Circular No. 40-04/D19

Series 2000 Genset Engines Changed connection point for coolant venting

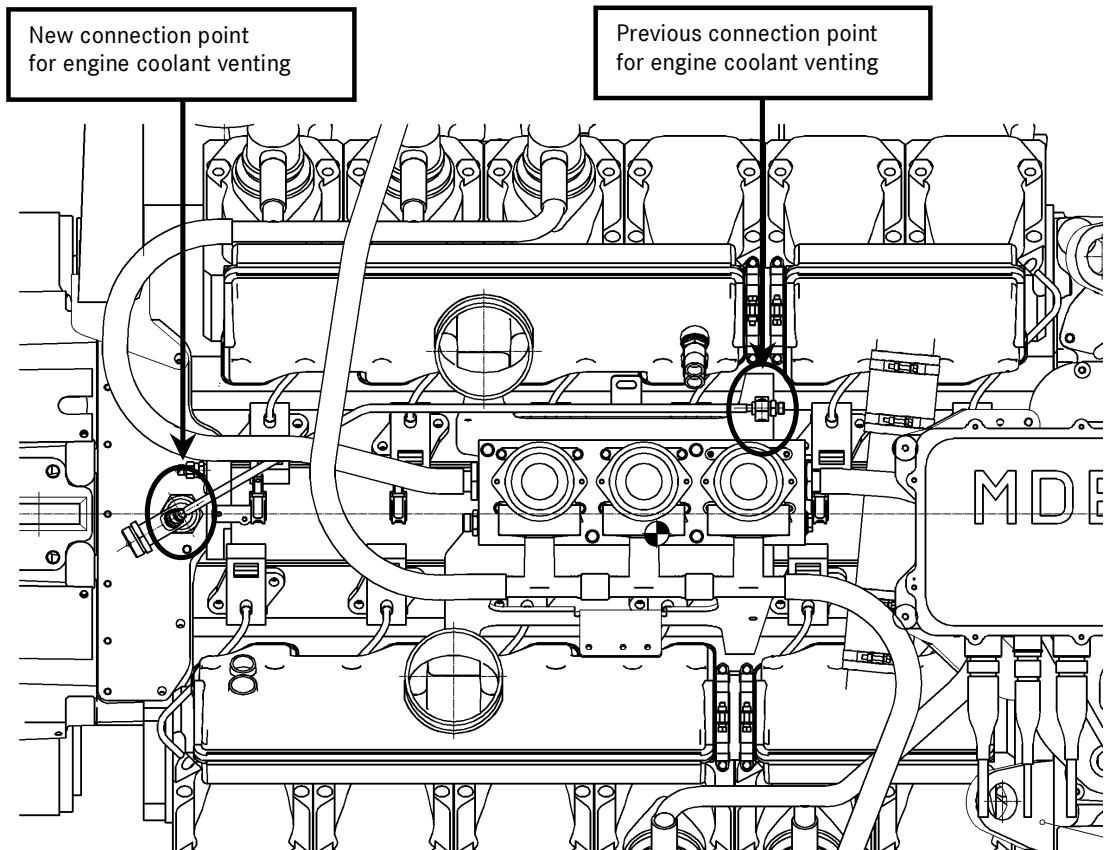
The connection point for engine coolant venting on Series 2000 genset engines has been changed (see drawing on next page).

The previous engine-side line between the elbow with the connection point "Inlet pre-heating line" and the previous connection point is no longer fitted. In future, the venting line must be connected directly at the connecting elbow. Connection geometry remains unaltered.

For engines with air-charge-air cooling a suitable hose line is supplied. It must be ensured that the hose line is installed with a continuous upward incline.
